ADDENDUM NO. 2

January 12, 2024

New Castle County Vocational Technical School District
Hodgson Vo-Tech High School
Bid Package D – Building Envelope and Fitout
Page 1

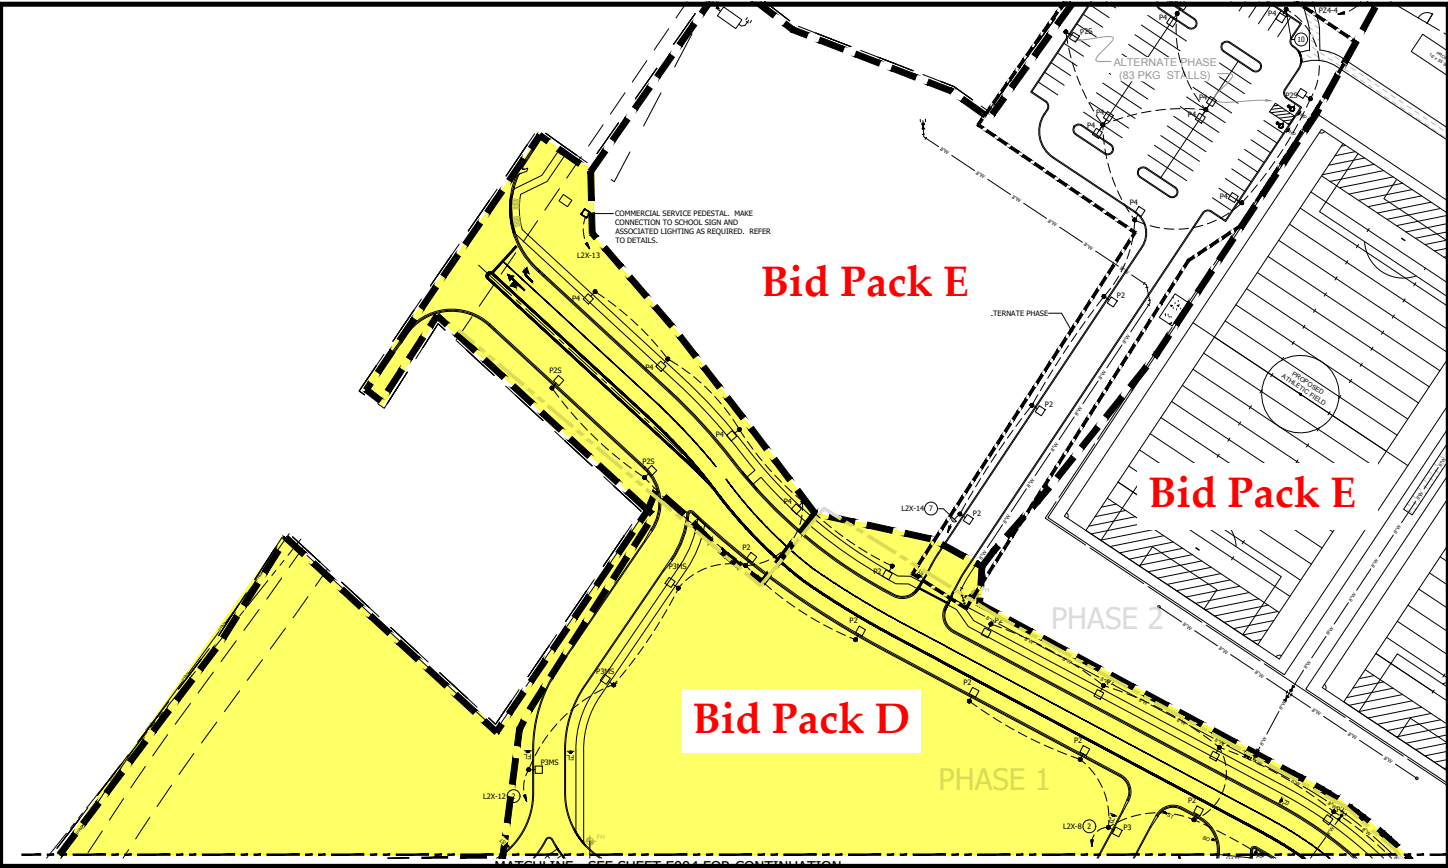
223	1/10/24	Union Wholesale			STC DOORS: The manufacturers listed in the wood door spec can only do a max STC rating of 47, we'll need direction on the doors rated higher. Be advised that doors with a STC rating greater than 54 are usually thicker than 1 ¾”, with doors near 60 being 3-4” thick. This is also true of HM doors.		Design Team: JV

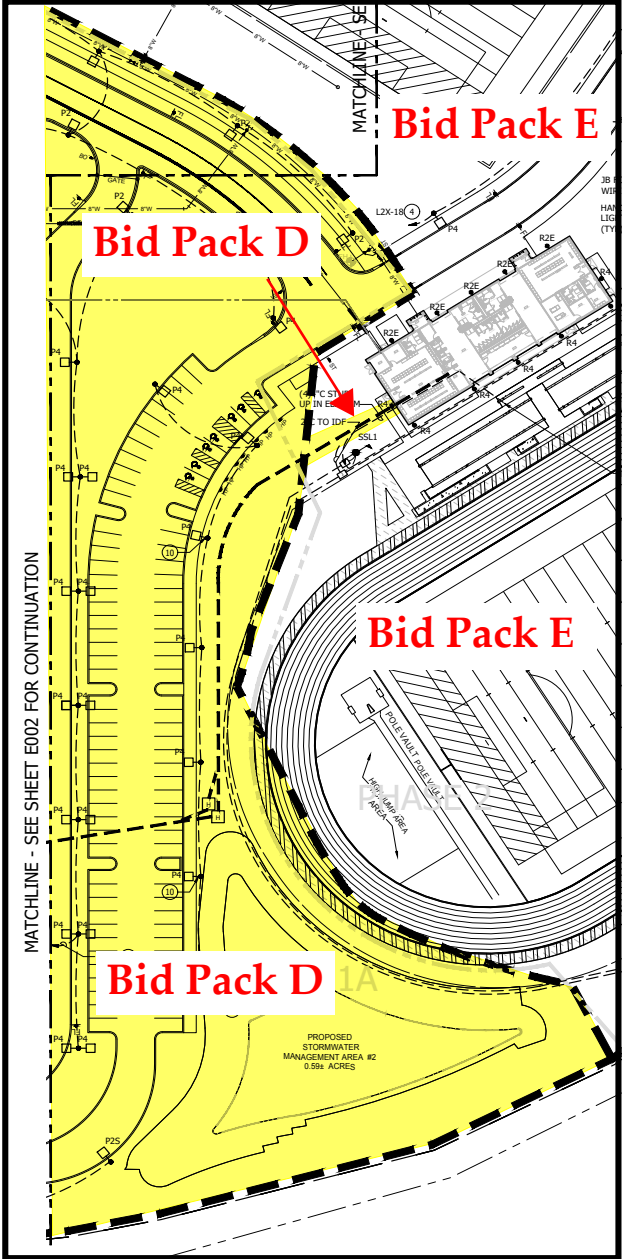
232	1/11/24	North East Contractors		013700	Are we are going to be required to upload our Revit model to the cloud (i.e. Autodesk Construction Cloud, or something like that)?	Yes		2
233	1/11/24	North East Contractors		013700	Are we going to be required to work with a cloud-based model for our modeling, or be able to upload individual Revit or Navisworks files?	Yes		2
234	1/11/24	Corporate Interiors		011100	Contract # 16 Flooring: Can we use another vendor for the RF-1 raised floor? Steelcase makes one we like.	If you have a substtution that is equal to the system specified, please submit as a full substitution request to EDIS. Kevin Lucas at klucas@ediscompany.com		2
235	1/11/24	RA Kennedy		011100	Contract D-13: Are we including the translucent wall panels in our SOW?	Yes, Contract # D-13 should include the Translucent Wall Assemblies per the scope.		2
236	1/11/24	Precision Doors & Hardware			Rite doors EE elevation These doors cannot have an STC rating, okay to exclude STC? These doors should ALL have hardware set 78.0, as well.		Dsign Team: JV

Ref: E005 - Electrical Site Plan, E006 - Electrical Site Plan

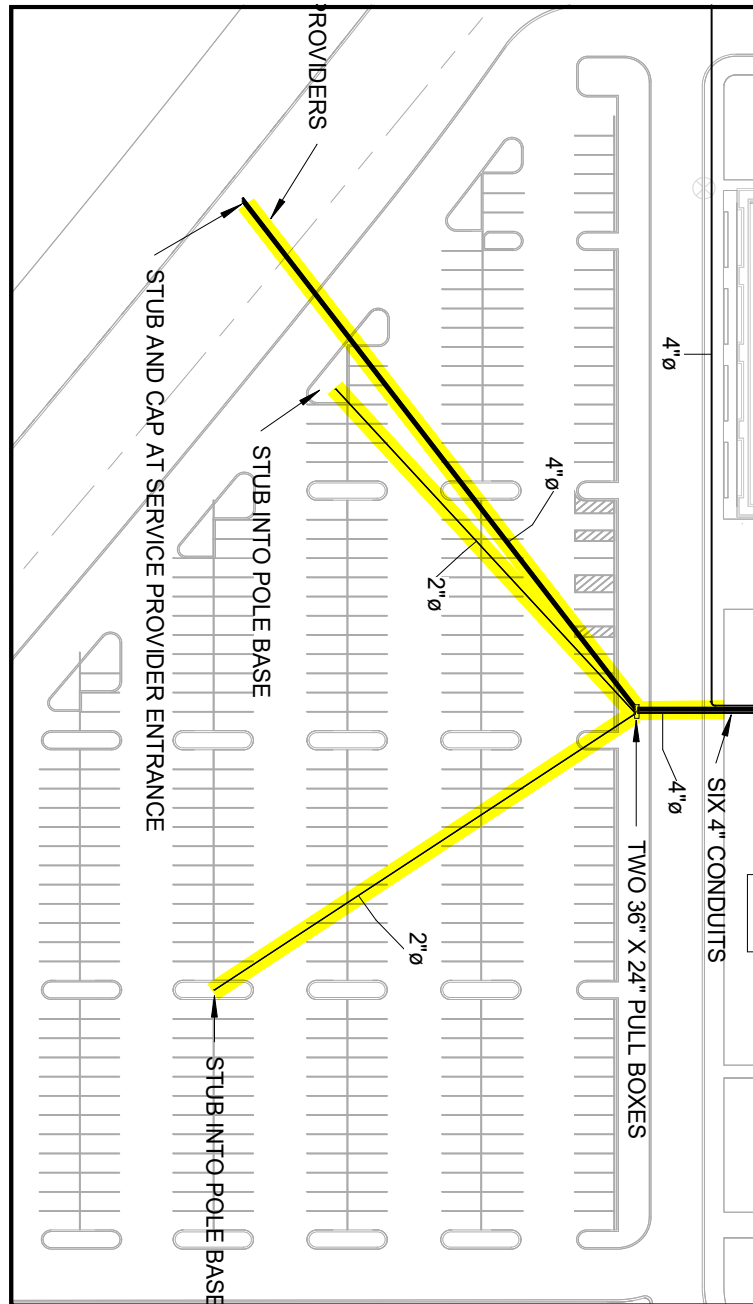
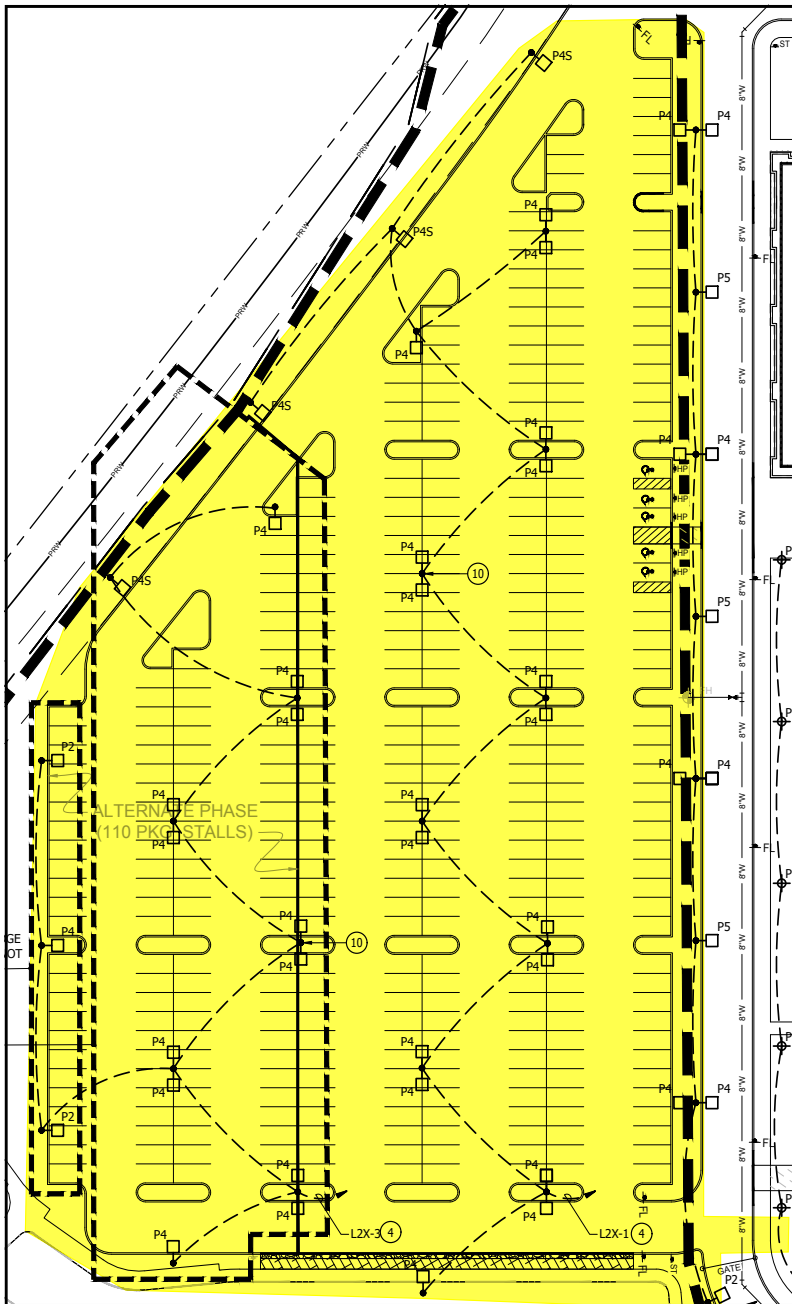
Contract BPD D-34 Electrical, Lighting and Fire Alarm Systems will be responsible for the work located only within the highlighted areas on this attachment.

Work to be excluded from BPD D-34 Electrical, Lighting and Fire Alarm Systems:

Contract BPD D-34 Electrical, Lighting and Fire Alarm Systems will be responsible for providing the conduits from the quazite box into the building, all wire pulls, site lighting and the raceways for the security cameras. This contract (D-34) will also be required to adjust/set the quazite box at final grade.
